THE CITY OF SAN DIEGO

MEMORANDUM

SUBJECT: LEIDY RESIDENCE CDP – PROJECT NO. 639782

The subject project's Exhibit "A" has been updated to include the following:

A1.0e

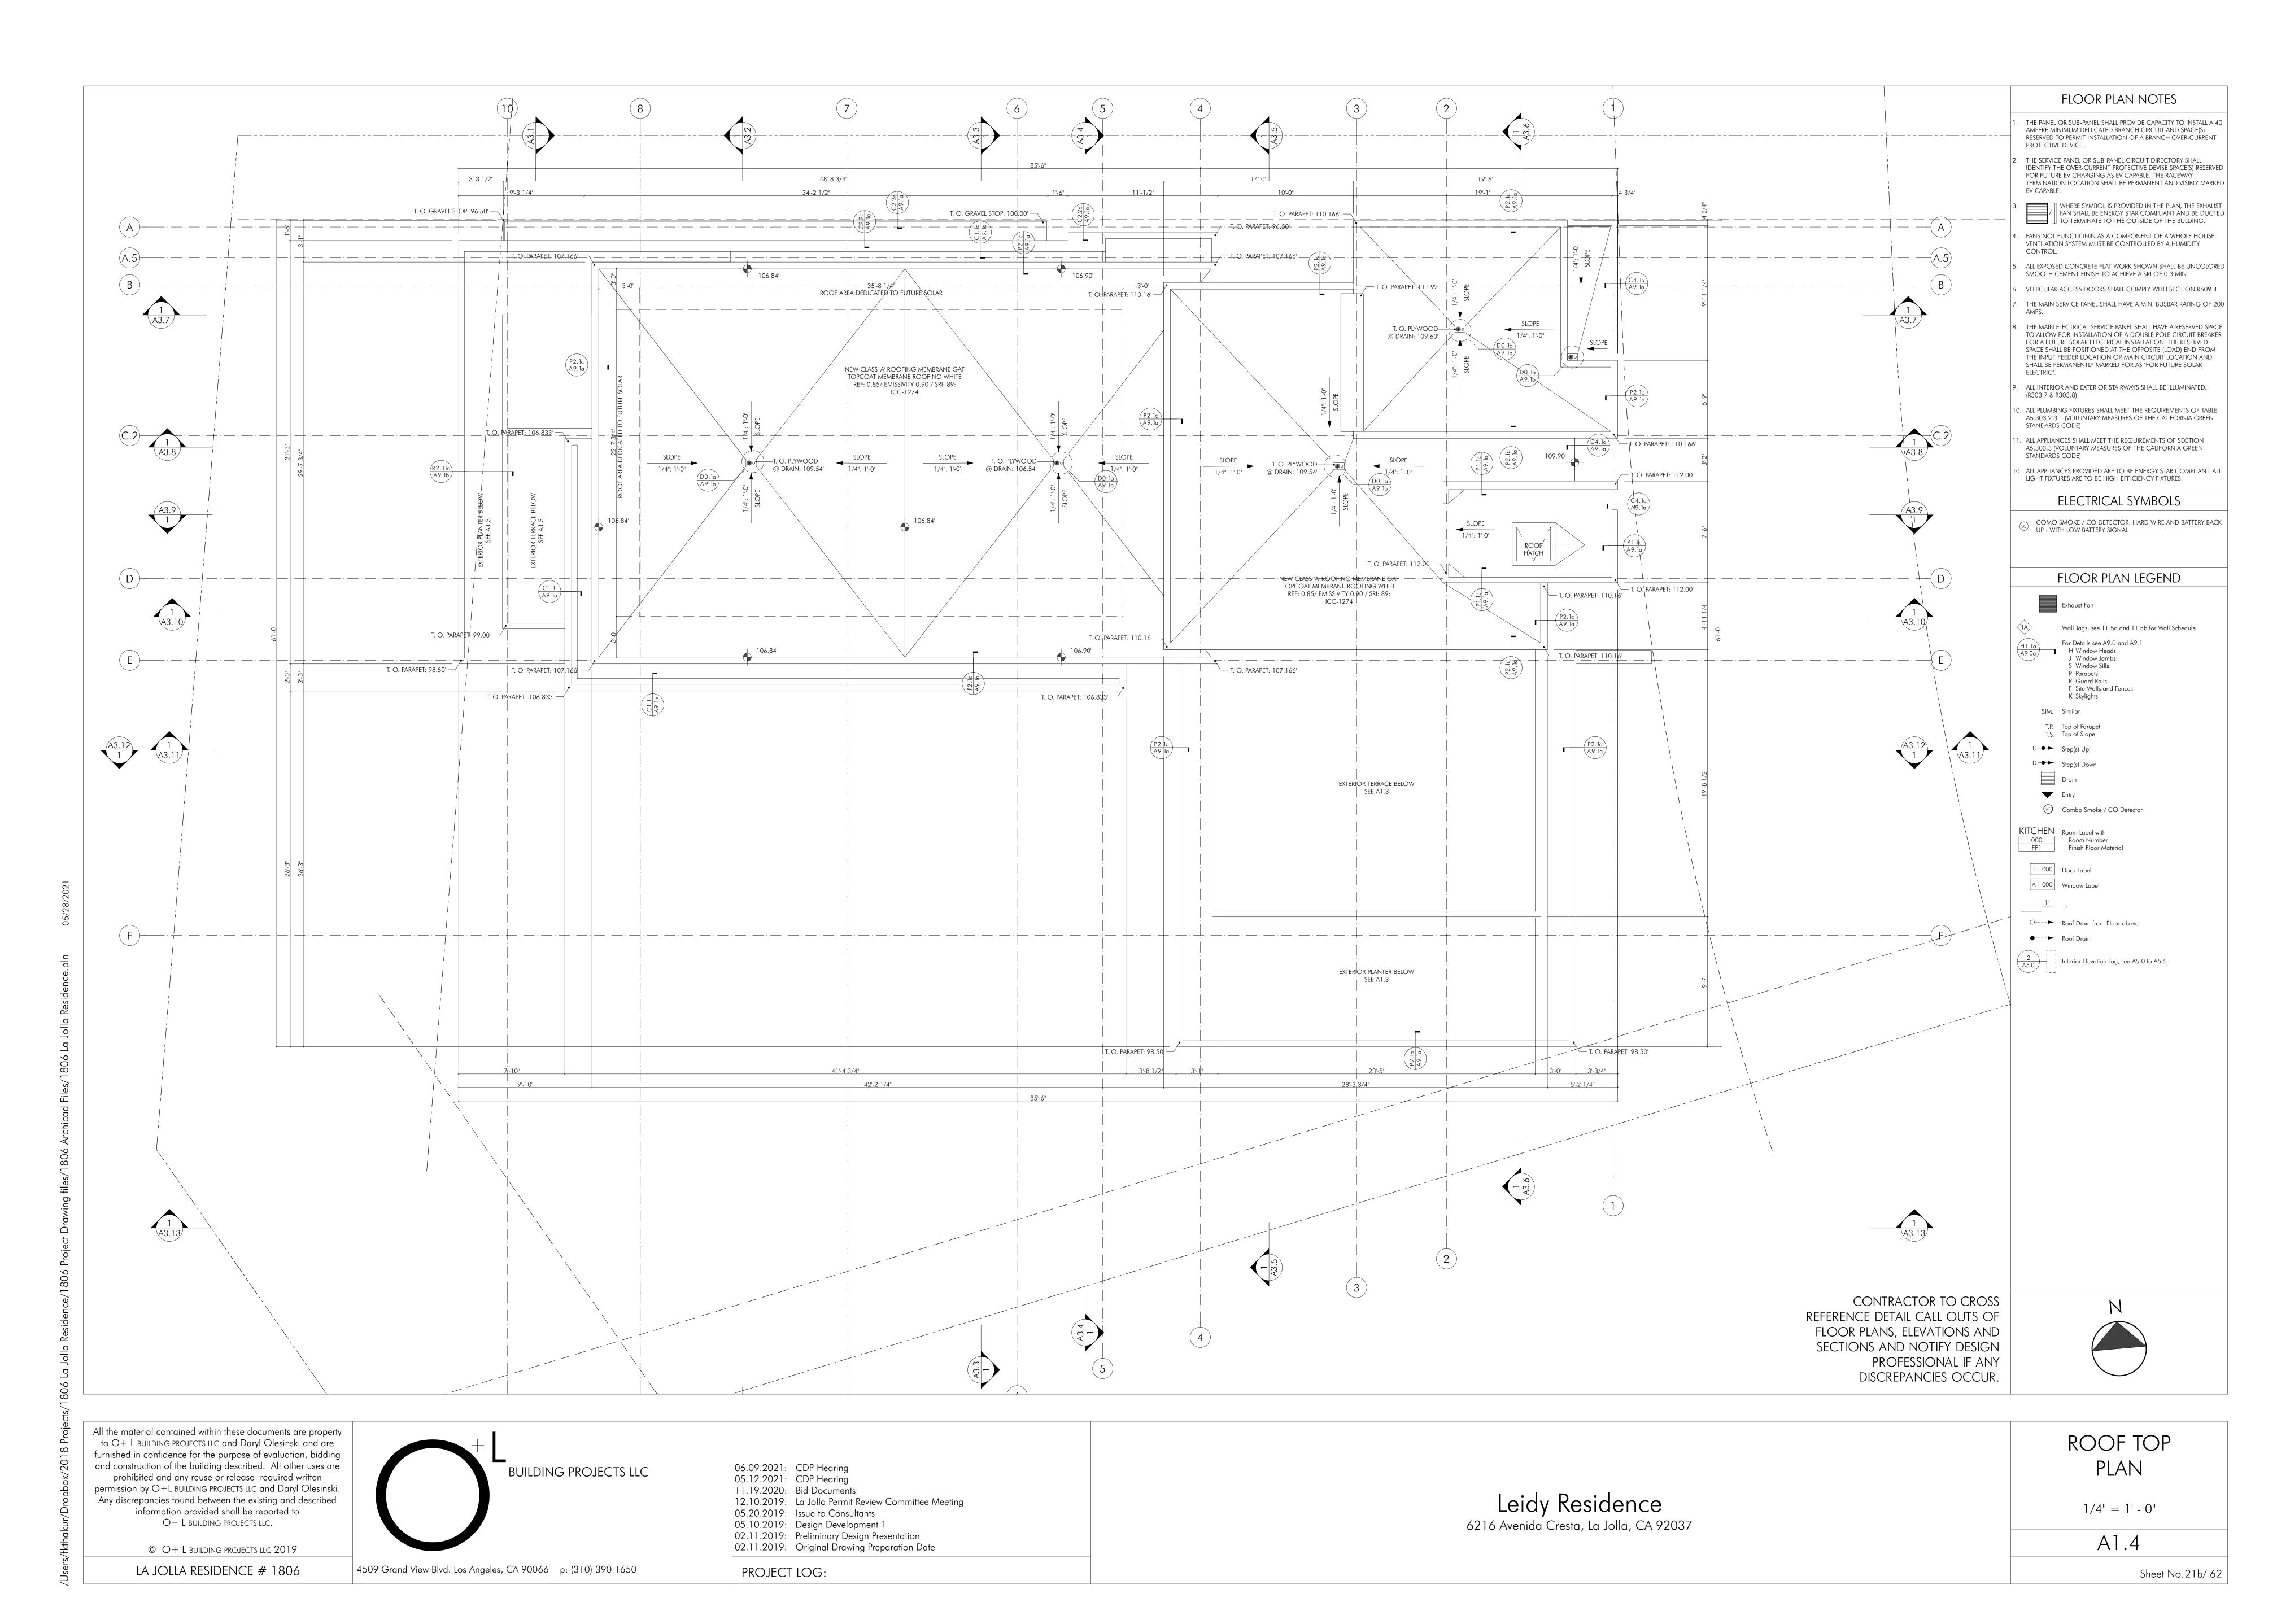
- Renamed the Guest Quarters to an Accessory Dwelling Unit (ADU).
- Revised the Gross Floor Area (GFA) calculation to include the Basement Level ADU and removed the area which was once crawlspace to slab on ground.
 - o Updated Sheet A1.0e to show area not exempt from GFA.
- Reduced height for the retaining wall and added retaining wall labels.
